United States Department of the Interior

April 9, 2024

In Reply Refer To:
FWS/R4/ES/DCN080741

Independent Technical Review of the Revised Twin Pines Permit Application Hydrologic Modeling

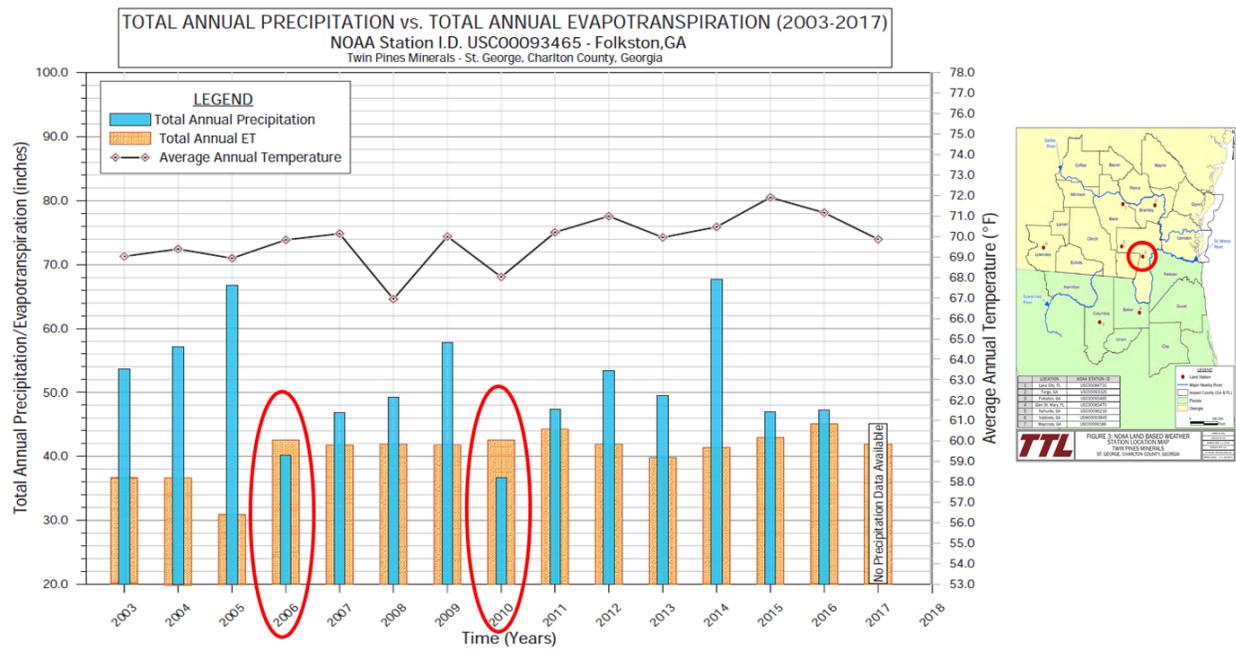
This modeling attempt assumes that lowering recharge rate from 4.13 inches/year (representing ‘average’ conditions) to 3.5 inches/year is appropriate to simulate ‘dry’ conditions. This is simply unrealistic. As can be seen in Figure 1, 3.5 inches per year of recharge does not accurately represent dry conditions, when the recharge values should be *negative*.

FIGURE 2. DAILY PRECIPITATION DATA AT FOLKSTON, GA, FOR 2-YEAR PERIOD.

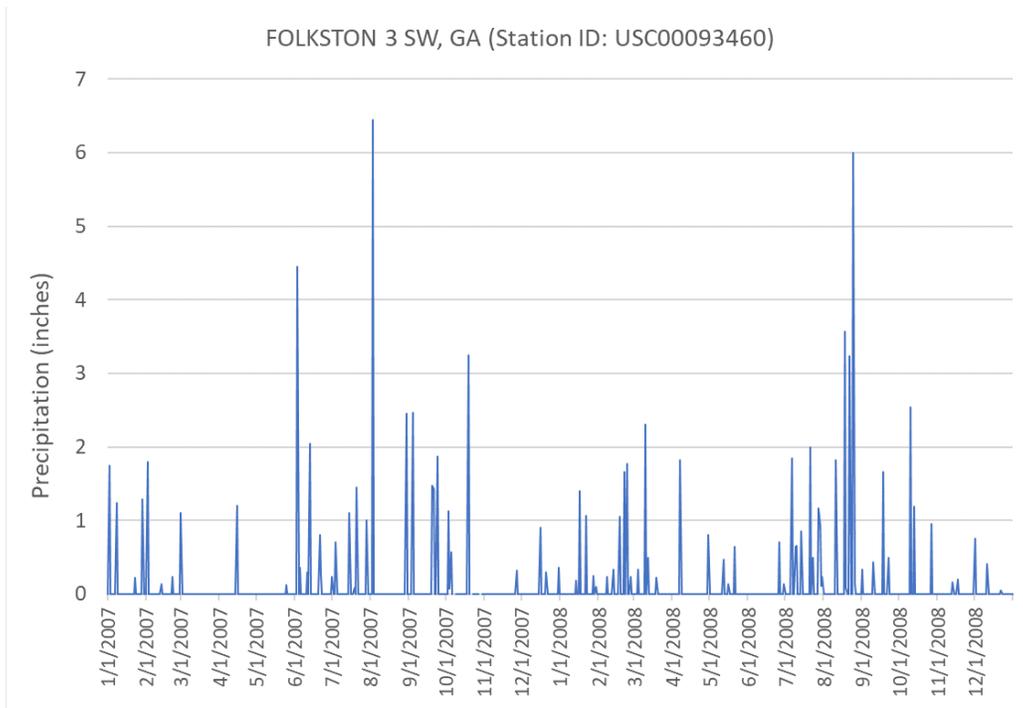
Figure 1 and Figure 2 in this report illustrate the substantial daily, seasonal, and interannual variability in precipitation within the region, emphasizing the importance of incorporating spatiotemporal variability in recharge rates into the model. It is critical to appropriately represent the drought conditions in the models for evaluating the mining impacts on ONWR, particularly during extreme events.

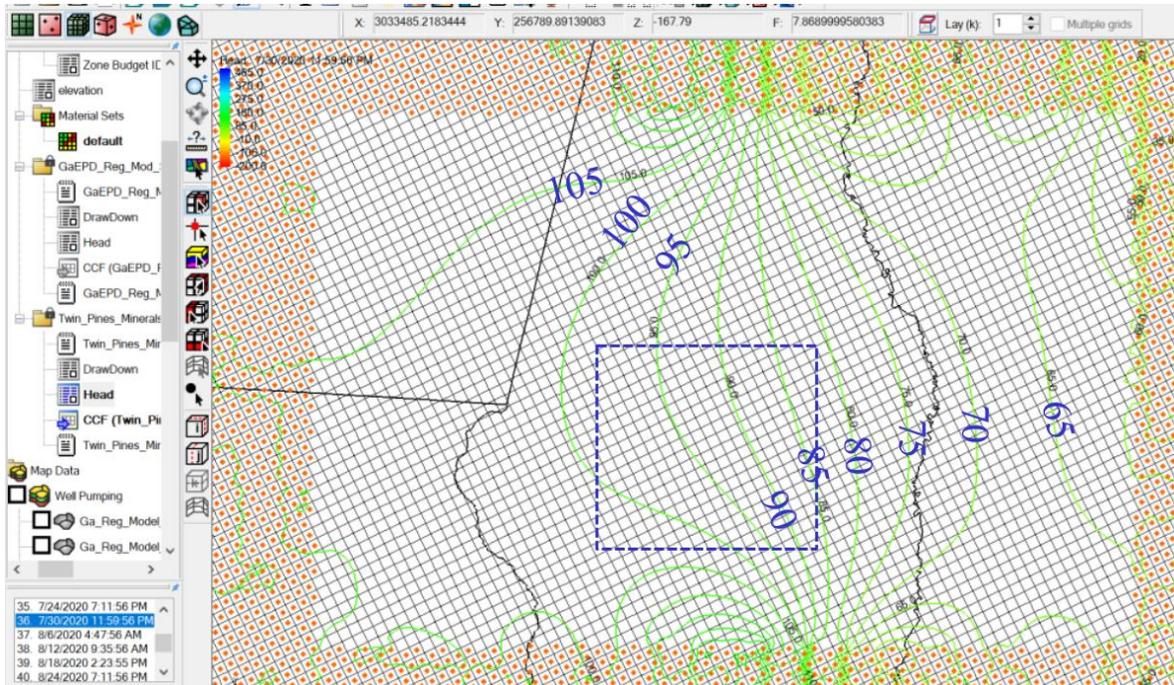
1. The two contour surfaces for January 1, 2020, and for July 30, 2020, are exactly the same. The likelihood of not having at least a small amount of variation in the location of the isolines seems minimal. This issue causes concerns that the State Water Plan transient model is not capable of modeling seasonal differences, or that there was potentially an error in the presentation or interpretation of the model results. This is discussed in more detail in (Bahm & Paudel, 2023). For example, in (Bahm & Paudel, 2023), Figure 16 shows groundwater elevation and precipitation for station PZ-01 (close to Trail Ridge) clearly depicting the considerable difference in groundwater levels in June and July (e.g., greater than 4 ft.). This contradicts the claim that *“The lack of change in hydraulic heads between January and July indicates that a steady state model could be used to simulate conditions at the mine”* made in Zeng, 2023.

2. The units on the isolines lines are not given, but as can be seen in Figure 4, the values around Trail Ridge only reach a maximum of 105. If these units are presumed to be feet, they are nowhere near the actual stages along Trail Ridge which have a measured range from

3. If the isolines denote stages in feet, the contour surface in Kennedy's model around Trail Ridge (Figure 4) has the highest stages in the west and the lowest stages in the east, with a constant decreasing slope in between. The model does not show a hydraulic ridge in the Trail Ridge area. Actual stage measurements in the area show Trail Ridge with high stages (~160-170 ft) along the centerline of the ridge, with decreasing stages towards the east and west (see measured groundwater surfaces in Figures 7, 8, and 9 in (Holt R. M., Tanner, Smith, Patton, & Lepchitz, 2019-lb)).

GA-EPD should provide more detailed documentation of their model and Kennedy's analysis and substantiate their conclusion that steady-state modeling is appropriate. With the information currently provided in Dr. Kennedy's letter to Mr. Wiedl, this argument appears flawed.

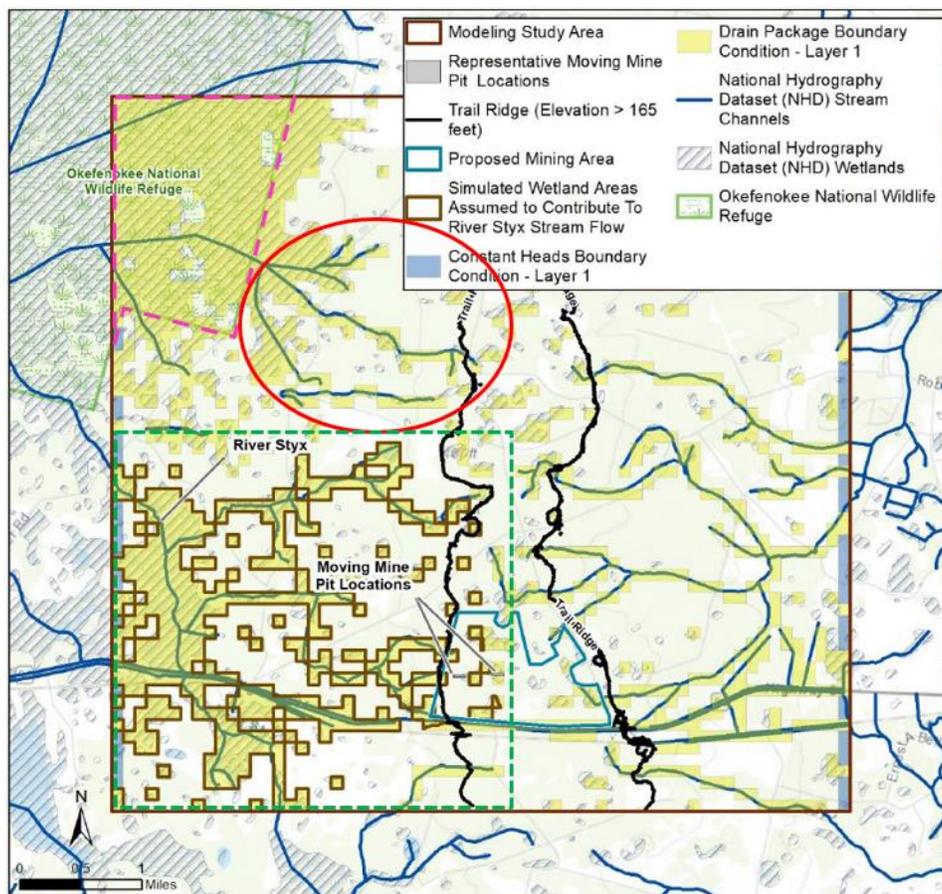
It is unfortunate, however, that GSI went back to using the incorrect analysis method for its analyses in Section 4.8 of (GSI, 2023-W), where they again quantified changes in flows north of the mine instead of directly downstream of the mine (where the effects on ONWR are most likely to occur).

DRAIN CELLS (YELLOW) IN THE MODEL. THE PINK DASHED LINE INDICATES THE DRAIN CELLS THAT WERE USED TO QUANTIFY CHANGES IN FLOWS TO ONWR IN (GSI, 2022-O). FLOWS FROM CELLS WITHIN THE RED CIRCLE (UPSTREAM OF THE PINK DASHED AREA) THAT WOULD HAVE EVENTUALLY REACHED ONWR WERE NOT CONSIDERED IN THOSE ANALYSES. MORE IMPORTANTLY, IN (GSI, 2022-O), FLOWS FROM DRAIN CELLS WITHIN THE GREEN DASHED SQUARE THAT WOULD FLOW DIRECTLY FROM THE MINING SITE INTO ONWR WERE OMITTED WHEN QUANTIFYING IMPACTS OF THE MINE ON ONWR. IN A SUBSEQUENT ANALYSIS FROM (GSI, 2023-W), THIS ERROR WAS CORRECTED, BUT YET ANOTHER ANALYSIS IN THE SAME REPORT REPEATS THE ERROR.

FIGURE 7. MODEL OUTPUT FROM THE GSI STEADY-STATE MODEL SHOWING PREDICTED MINING EFFECTS EXTENDING TO THE SOUTHERN BOUNDARY OF THE MODEL DOMAIN. REPRODUCED FROM FIGURES 4 AND 9 IN (GSI, 2023A). RED CIRCLES ADDED BY THE AUTHORS OF THIS REPORT.

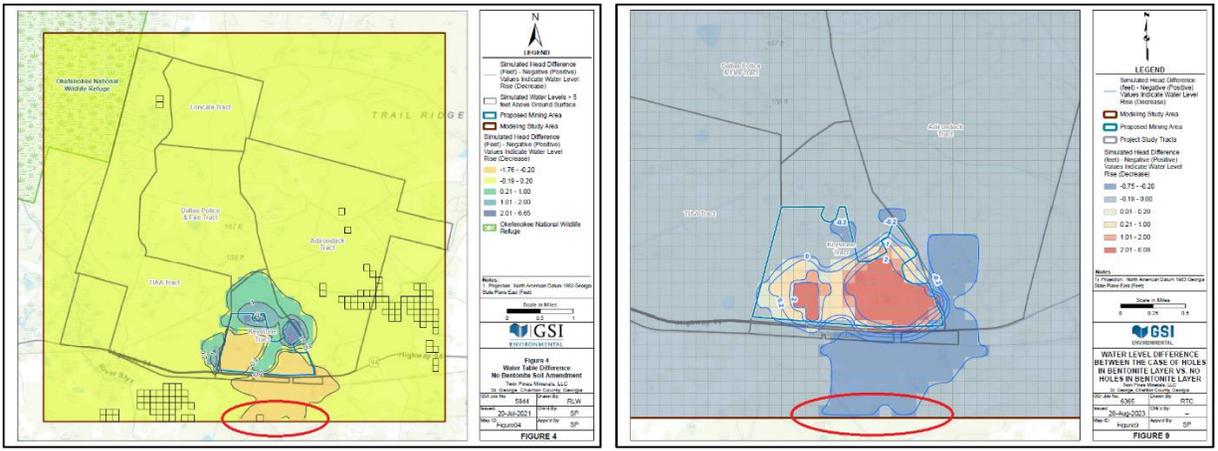
NPS maintains its concern that the positioning of the no-flow boundaries is a problem with the GSI model. Proper modeling practices state that the boundaries should be far enough away from the area of interest being modeled that the impacts of the area will not reach the boundary. Figures 4 and 9 of (GSI, 2023a) depict model output of head difference maps that clearly show predicted effects reaching the southern boundary of the model. These graphics are reproduced in Figure 7 of this report.
